FIRE SAFETY FOLLOW UP INSPECTION

Factory Name	MEGHNA KNIT COMPOSITE LIMITED		Accord ID	9508
Address	SRIIPUR ROAD, GILARCHALA, SRIIPUR			
Inspection Date	08/04/2014		Report Received Date	
Date of 1st Follow-up	04/09/2014	Date of 2nd Follow-up	07/12/2015	
Date of 3rd Follow-up	16/03/2016	Date of 4th Follow-up	04/09/2016	
Date of 5th Follow-up	23/11/2016	Date of 6th Follow-up	07/02/2017	
Date of 7th Follow-up	30/04/2017	Date of 8th Follow-up	10/08/2017	
Date of 9th Follow-up	02/04/2018	Date of 10th Follow-up	01/08/2018	
Date of 11th Follow-up		Date of 12th Follow-up		
Date of 13th Follow-up		Date of 14th Follow-up		
Inspected by	Johana Sharmin

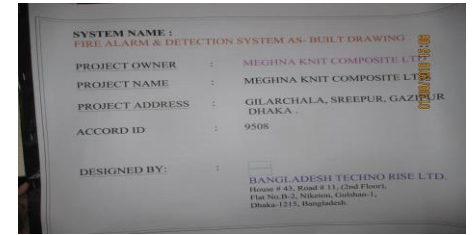
13 The fire alarm system is antiquated, not a listed system, and does not provide alarm and notification features consistent with acceptable standards.

Replace the fire alarm system with a new, listed addressable fire alarm system in accordance with NFPA 72.

On 7th February 2017 As action plan of the factory: Partially corrected. Reviewed drawing from Accord was available during 6th follow-up inspection. Installation was almost completed. Fire doors, HVAC system, fire pump controls should be interfaced with FACP if applicable. Factory have to prove whether the installed fire alarm cable & fire alarm product has been certified by any third party. (Commissioning of the system in front of contractor/ 3rd party will be done by Accord)
 On 30/04/2017: In progress. T&Cx required.
 On 10.08.2017: In progress. Testing & commissioning is required.
 On 02/02/2018: Completed. T&C is pending.
 On 01/08/2018: Installation is completed. Awaiting for T&C.

We have installed the listed addressable fire alarm system as per the NFPA 72.

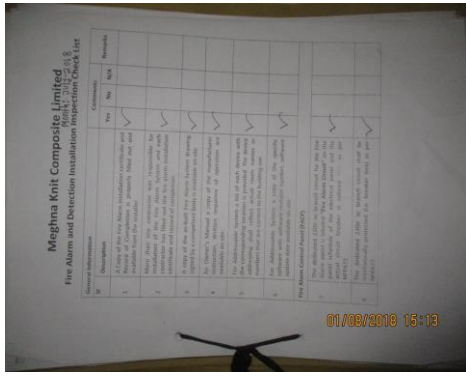
15 Testing and maintenance records for the fire alarm system were not available.

Inspect, test and maintain the fire alarm system, and keep written records on-site, in accordance with NFPA 72.

On 16/03/2016: In progress. It is an integrated part of fire alarm system.
 On 04/09/2016: It is an integrated part of fire alarm system.
 On 23.11.2016: It is an integrated part addressable fire alarm system.
 On 7th February 2017 As action plan of the factory: Corrected.
 On 30/04/2017: Corrected
 On 10.08.2017: Corrected.
 On 02/02/2018: Corrected.

Accord has reviewed the Fire Detection system's drawing and design on 15/03/2016. Based on review we're in process to install and modify the fire alarm system and we'll maintain the testing & maintenance record accordingly.
